**MONTGOMERY COUNTY DEPARTMENT OF PARK AND PLANNING**

**MEMORANDUM**

REVIEW TYPE: **Site Plan Review**  
CASE #: **820060090**  
PROJECT NAME: **Montgomery Village CVS**

APPLYING FOR: Approval of 11,902 square feet of retail with a 396.5-square feet drive-thru in Montgomery Village

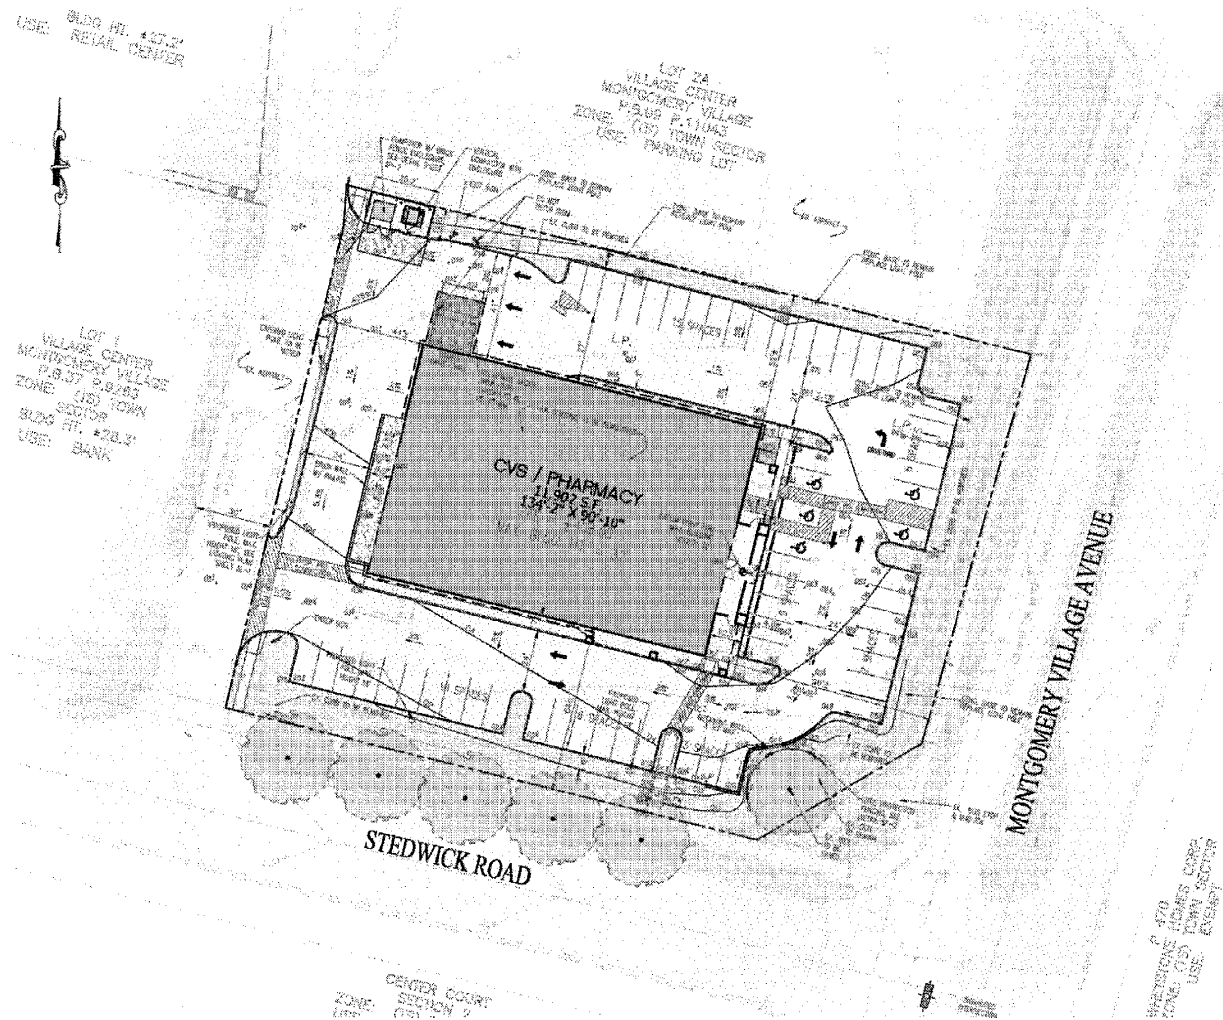
- a. Provide building setbacks on the site plan.
- b. Provide the location and dimensions of all PUE easements on the site plan.
- c. Provide the width of the proposed internal sidewalks, the pedestrian connections and the drive-aisles on the site plan.

- d. Provide the location and width of all existing and proposed sidewalks along Montgomery Village Avenue and Stedwick Road.
- e. Clarify whether the drive-thru area is included in the overall floor area. Revise the total floor area accordingly in the site plan data table.

- f. Provide the correct number of required and proposed parking spaces on the site plan.
- g. Provide a total of three bike racks on the site plan.
- h. Provide the location and dimensions of the loading space.

- i. Provide the top and bottom elevation for the proposed retaining wall.
- j. The data table on the site plan shall be revised to match the data table in the staff report.

Relocate the pedestrian connection in the southwestern portion of the property to the extent feasible so that it is not within the vehicular entrance area to the site.
